Amendment No. 24  
License No. DPR-31

ATTACHMENT TO LICENSE AMENDMENT NO. 24  
TO THE TECHNICAL SPECIFICATIONS  
FACILITY OPERATING LICENSE NO. DPR-31  
DOCKET NO. 50-250

Amendment No. 23  
License No. DPR-41

SAFETY EVALUATION BY THE OFFICE OF NUCLEAR REACTOR REGULATION  
SUPPORTING AMENDMENT NO. 24 TO LICENSE NO. DPR-31 AND  
AMENDMENT NO. 23 TO LICENSE NO. DPR-41  
FLORIDA POWER AND LIGHT COMPANY  
TURKEY POINT NUCLEAR GENERATING UNITS NOS. 3 AND 4  
DOCKETS NOS. 50-250 AND 50-251

Figure 3.1-1a

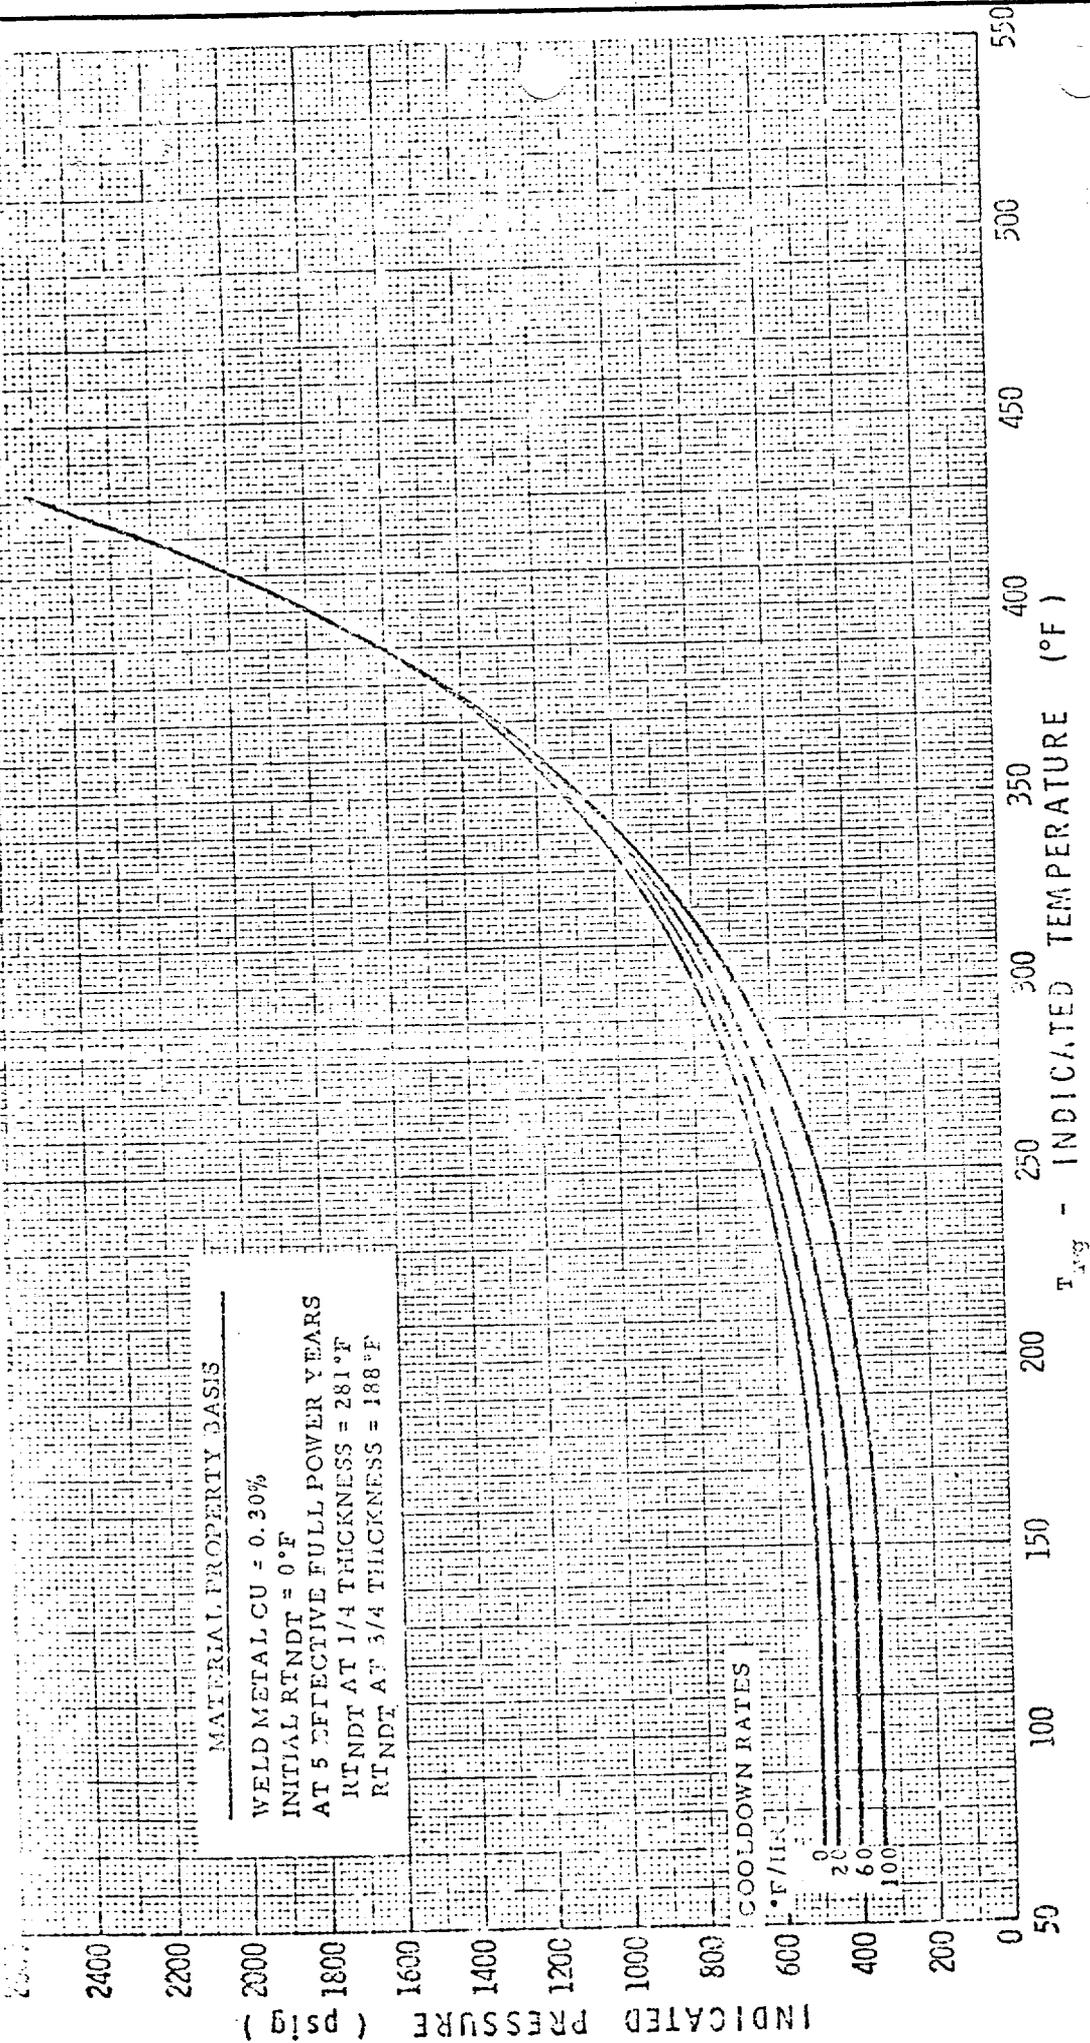
These amendments revise the Technical Specifications to change the reactor coolant pressure-temperature limits to account for neutron irradiation induced increases in reactor vessel metal nil ductility temperature. Please note that the same pressure-temperature limits apply to both Unit No. 3 and Unit No. 4 for five effective full-power years (EFPY).

Replace pages i, v, 3.1-2 thru 3.1-4, and B3.1-1 thru B3.1-4 with the attached revised pages. Replace Figure 3.1-1 with Figures 3.1-1a and 3.1-1b. Add Figures B3.1-1 and B3.1-2.

TURKEY POINT REACTOR COOLANT HEATUP LIMITATIONS APPLICABLE FOR PERIODS UP TO 5 EFFECTIVE FULL POWER YEARS.

TURKEY POINT REACTOR COOLANT COOLDOWN LIMITATIONS APPLICABLE FOR PERIODS UP TO 5 EFFECTIVE FULL POWER YEARS

Figure 3.1-1a TURKEY POINT UNIT 4 REACTOR COOLANT HEATUP LIMITATIONS APPLICABLE FOR PERIODS UP TO 5 EFFECTIVE FULL POWER YEARS.

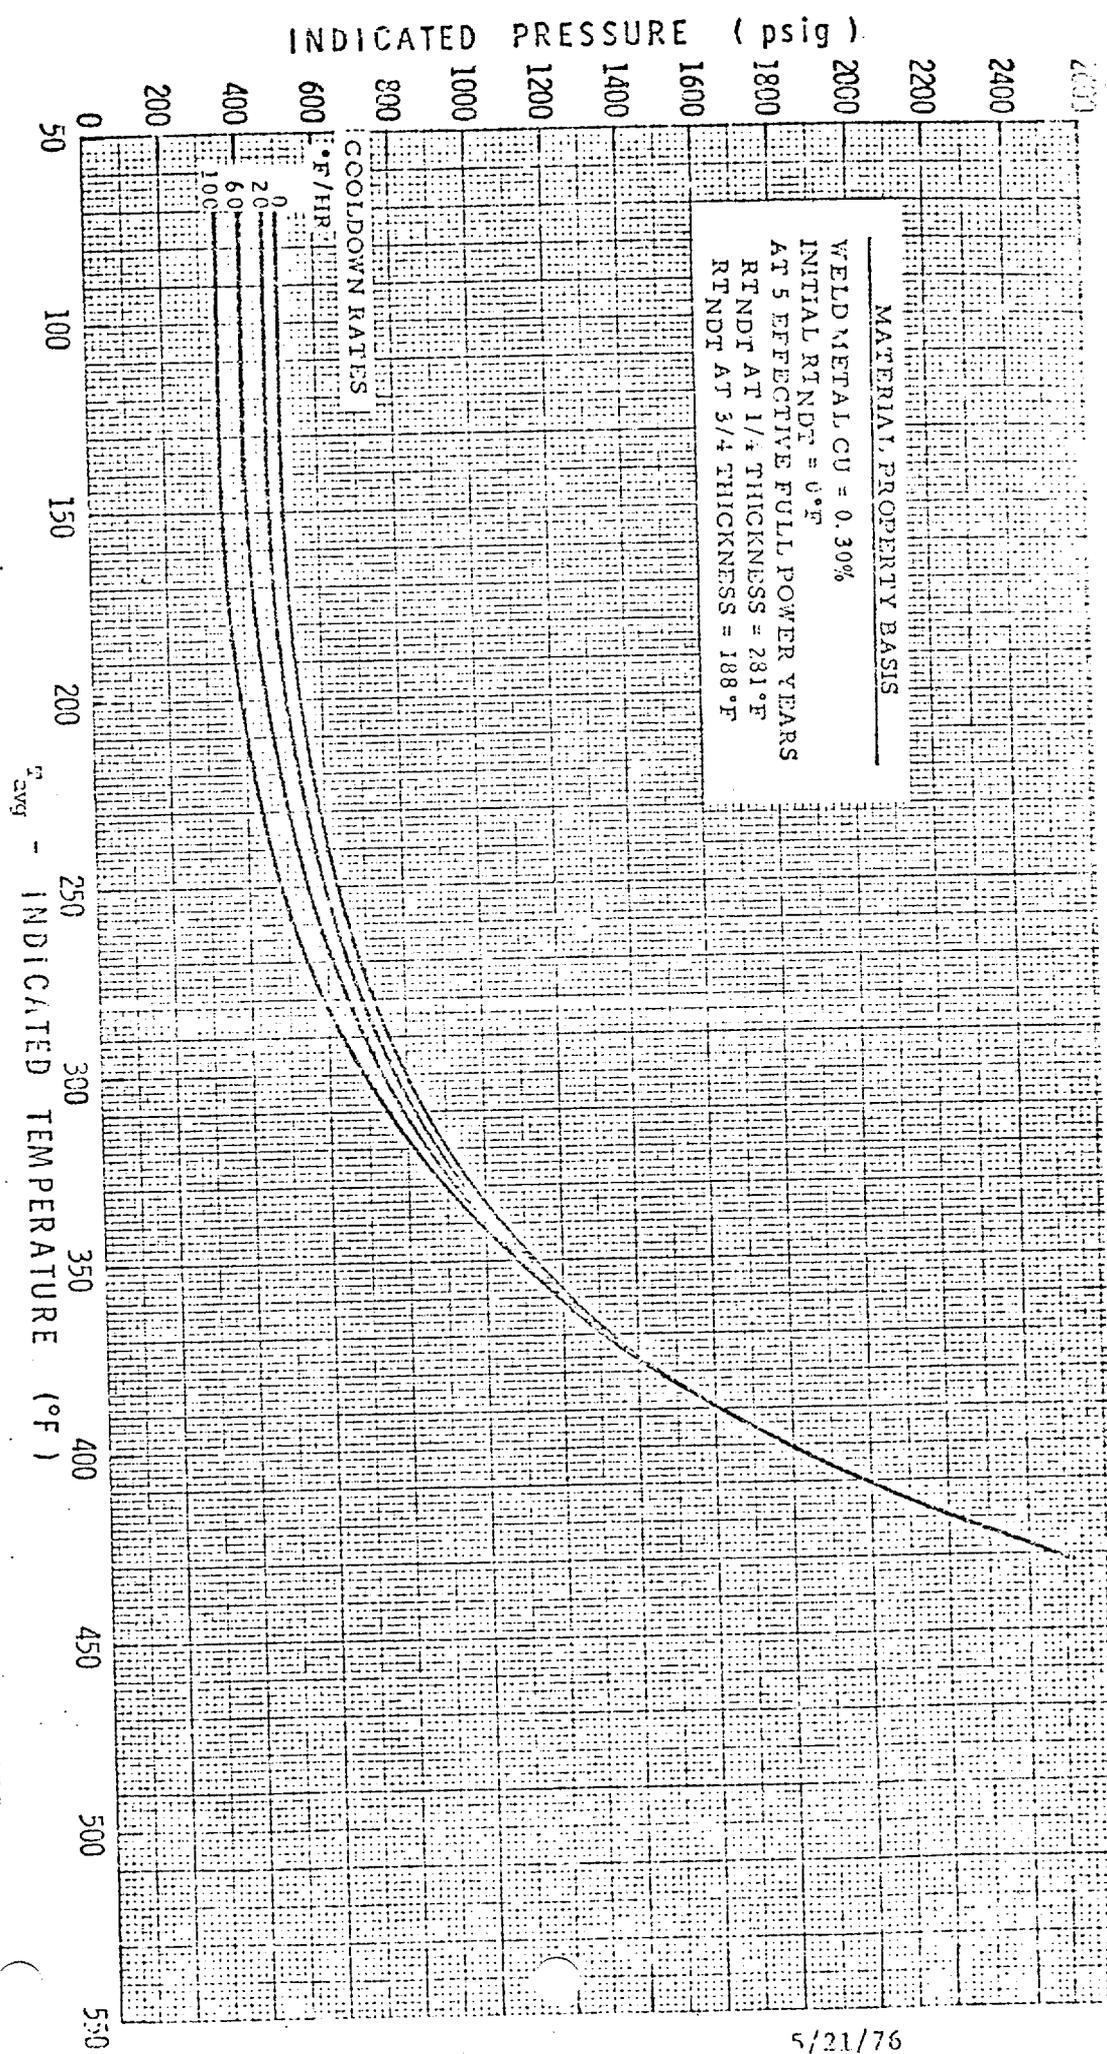
Replace pages i, v, 3.1-2 thru 3.1-4, and B3.1-1 thru B3.1-4 with the attached revised pages. Replace Figure 3.1-1 with Figures 3.1-1a and 3.1-1b.

neutron exposure, we have concluded that the more restrictive pressure-temperature limits proposed for Unit No. 4 should also be applied to Unit No. 3. In addition, we are deferring approval of the proposed limits for the period between 5 to 10 EFPYs pending further analysis of the welds in the reactor beltline region.

Figure 3.1-16. TURKEY POINT UNIT 4 REACTOR COOLANT COOLDOWN LIMITATIONS APPLICABLE FOR PERIODS UP TO 5 EFFECTIVE FULL POWER YEARS.

Figure B3.1-1

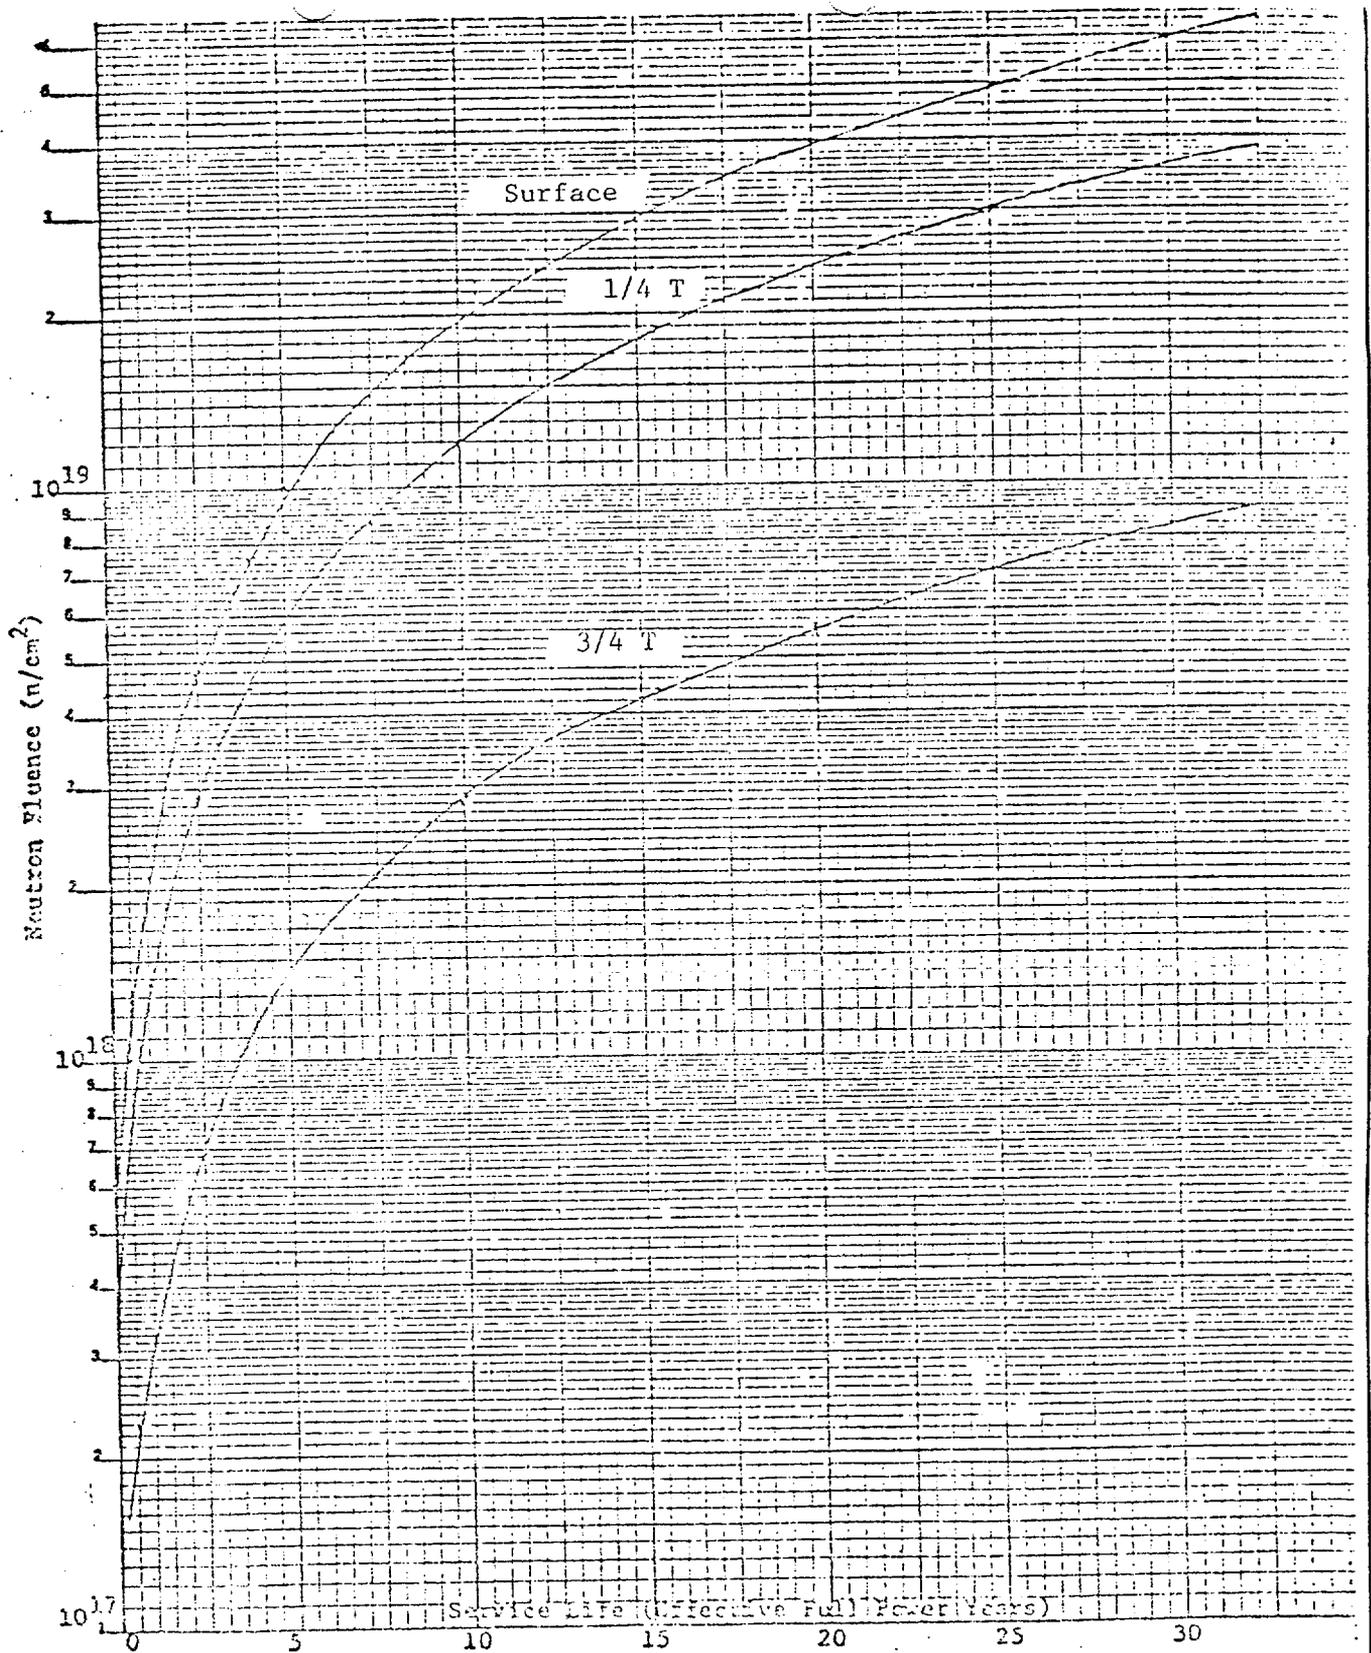
Add Figures B3.1-1 and B3.1-2.

Effect of Fluence and Copper Content on Shift of RT<sub>NDT</sub> for Reactor Vessel Steels Exposed to 550 °F Temperature
